Watermark Project

Response to submission from University of New South Wales

Prepared for
Shenhua Australia Holdings Ltd

Project No. G1501 October 2014
www.ageconsultants.com.au ABN 64 080 238 642

Figure 3-15 Cross section through Lake Goran

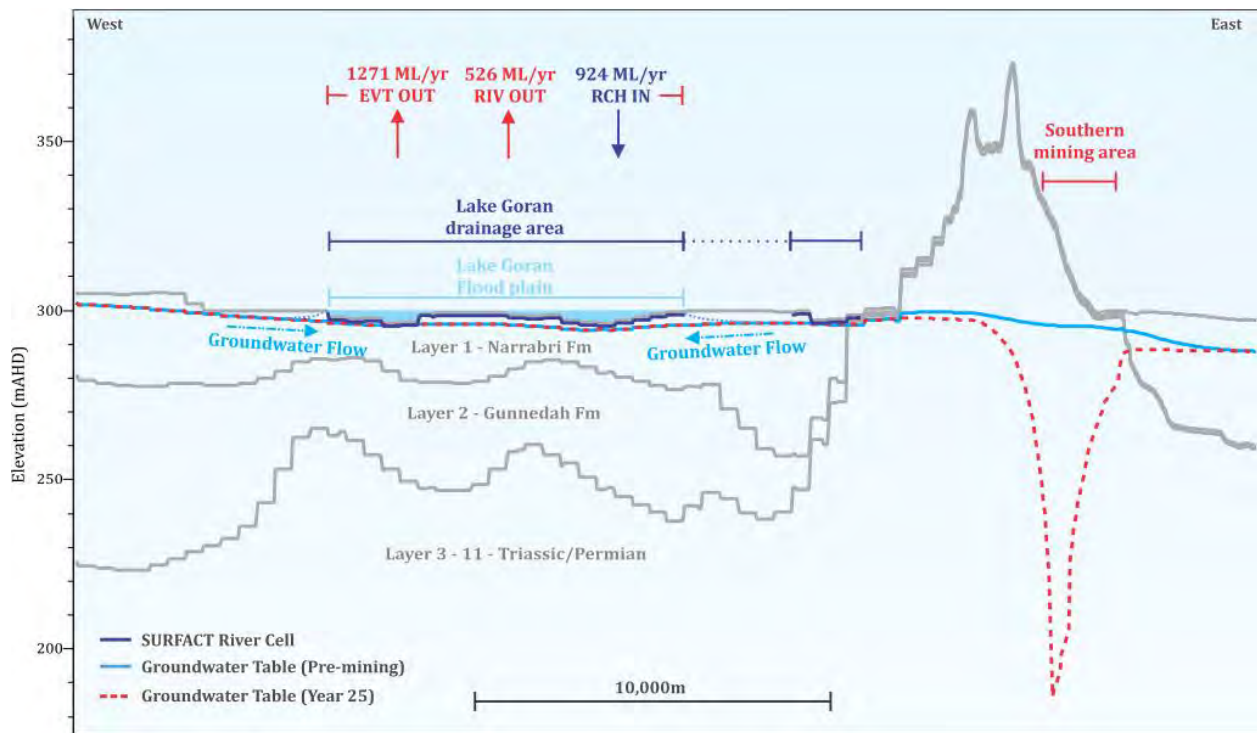
UNSW also imply Dr Noel Merrick of Heritage Computing disagreed with the conceptualisation of Lake Goran representing a net discharge zone. This is not correct – Heritage Computing simply outlined a change in the initial conceptualisation of Lake Goran from the start of the project to the final report.

The results show that Lake Goran is a localised feature, which does not directly interact with the Watermark Project. Groundwater flows into Lake Goran, which represents a groundwater depression.

Whilst events where the lake fills were not simulated, if they did occur the net effect would be to provide additional recharge to the groundwater system. Assuming Lake Goran heavily influenced the alluvial aquifer system during wet periods, groundwater impacts would be buffered due to increased groundwater through-flow surrounding the Project area. We anticipated this, and preferred to take a more conservative approach to representing the surface water/groundwater system in this area.

Figure 3-18 **UNSW Impact Graphic**

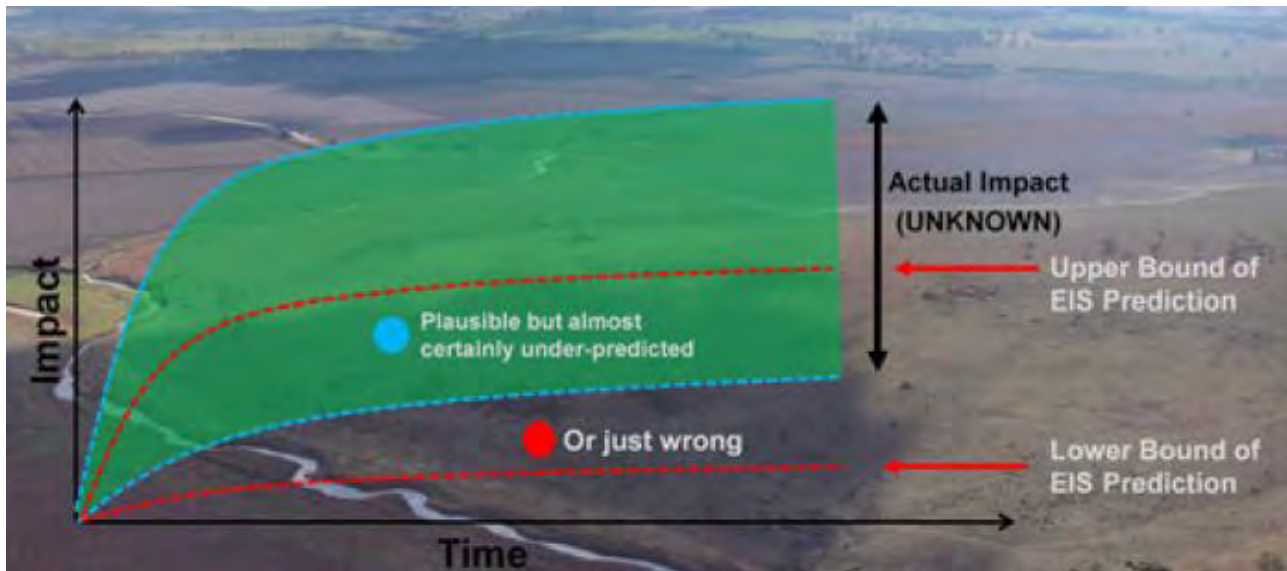
UNSW consider good science provides a plausible and conservative estimate of impacts, and go on to conclude the groundwater assessment for the Project was *'plausible but almost certainly under-predicted, or just wrong.'* They show this graphically in their presentation as reproduced in Figure 3-18 below.

UNSW appear to reach this conclusion simply because the groundwater model was not set up in a manner they would recommend. Of course we understand there are many different ways to represent natural processes in models, but UNSW appear to conclude without any modelling evidence, that because the model was not set up in a manner they would recommend the impacts predicted by the EIS must be under-predicted or wrong. They don't seem to consider the scenario that setting the model up in a manner they recommend could result in lesser impacts.

Figure 2-1 Groundwater recovery of the waste rock areas (EIS model)

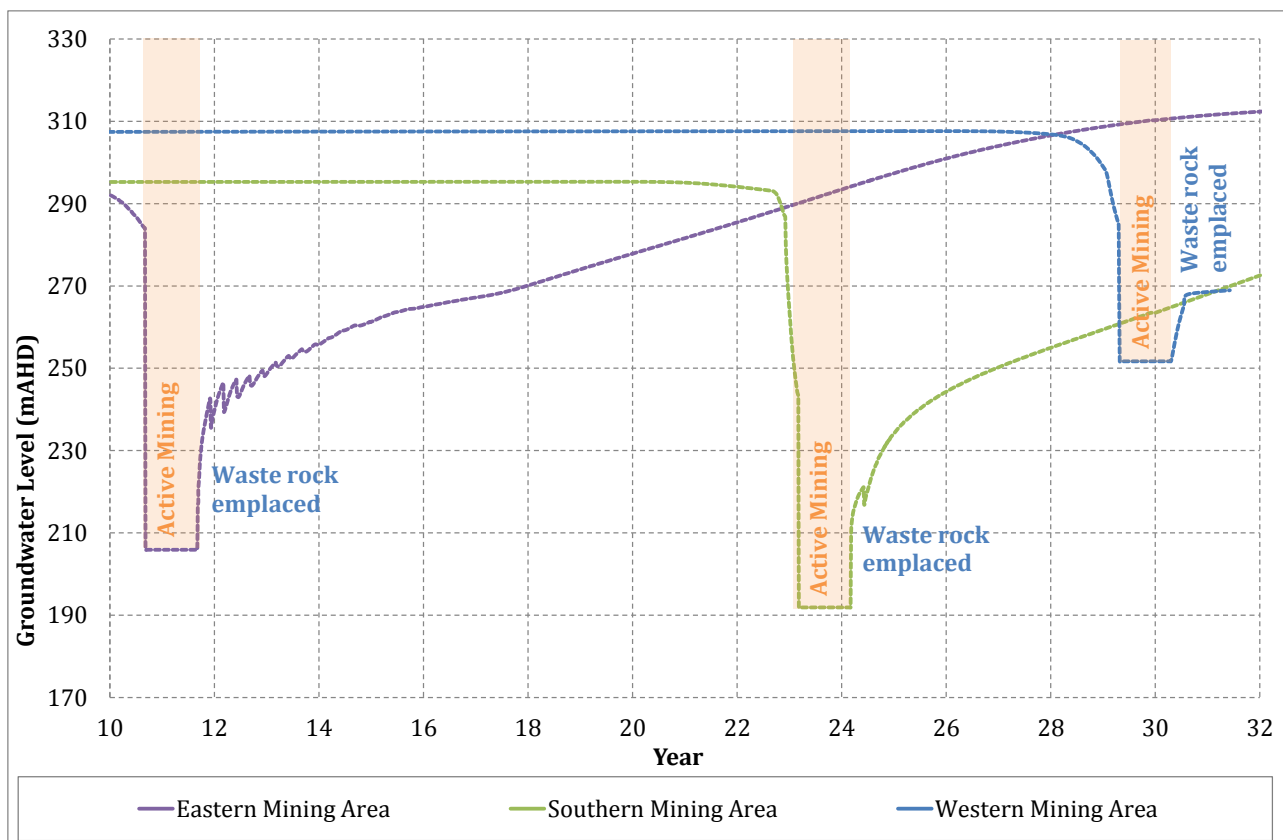
Dr Mackie raised a concern that the EIS model which emplaces spoil behind the active mining area (in line with the Project mine plans) might be buffering the drawdown impacts by allowing water pressures within the mined areas to begin recovering after mining passes through.

The spoils were represented with a relatively high hydraulic conductivity and storage parameters, typical of a productive aquifer. The effect of this is to slow recovery of water levels within the spoils. The parameters within the EIS model are considered likely to be at the upper end of the range in the spoil heaps, and therefore slow recovery and do not significantly impact on the zone of depressurisation around the mining areas. Figure 2-1 shows the groundwater level recovery at points within the emplaced waste rock areas in each mining area from the EIS model.

The results show a rapid recovery following the emplacement of spoil (~30m after 90 days), although a groundwater sink for regional groundwater levels remains for approximately 10 years after the closure of each mining area. For this reason, it is considered the recovery of groundwater levels within the spoil does not overly influence the regional groundwater drawdown predictions, and the staged approach adopted by the EIS model is valid, assuming the mine plan is implemented as proposed.

Figure 2-12 Cross section of water table surface (EIS model)

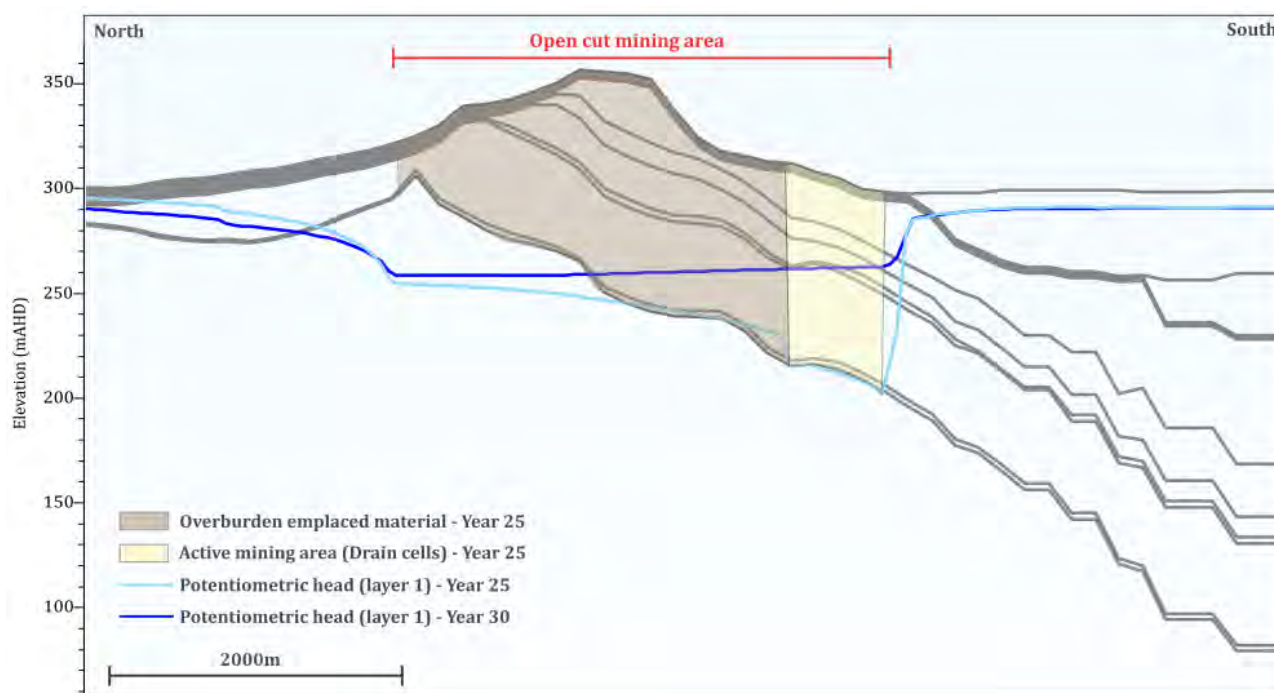
Dr Mackie also noted that: *"Figure 6 represents the EIS model with pore pressures indicated by the white contours. Close inspection of the zero pore pressure (water table) contour in the Southern Pit shows a highly erratic surface. Normally are relatively smooth surface that reflects the floor of the mined coal seam, would be expected (see Figure 7 for dewatered pit profile). The erratic surface identified in Figure 6 may be indicative of more general problems probably associated with recharge to spoils, or to unconventional assignment of drain cells or possibly discretisation issues. It is important to identify the reason for this behaviour since it may have implications for regional water table drawdown and mine water inflows."*

Upon analysis of the groundwater potentiometric heads, there is no visible erratic behaviour of the groundwater potentiometric surface throughout the model run. AGE provided Dr Mackie a figure which represented a model cell pressure head, which was contoured against the finite difference cell centres in the groundwater model. As such, the zero pressure contour represented an interpolated saturation surface, which was intended to display absolute saturation extents rather than represent the saturation surface. Graphical user interfaces (e.g. Groundwater Vistas 6) perform additional corrections in cells experiencing unconfined conditions ensure the zero pressure head contour is equal to the water table.

Figure 2-12 shows the water table surface at years 25 and 30 for the EIS model. Clearly, there is no erratic behaviour in the groundwater levels, and the re-saturation of groundwater levels in the waste rock appears realistic.
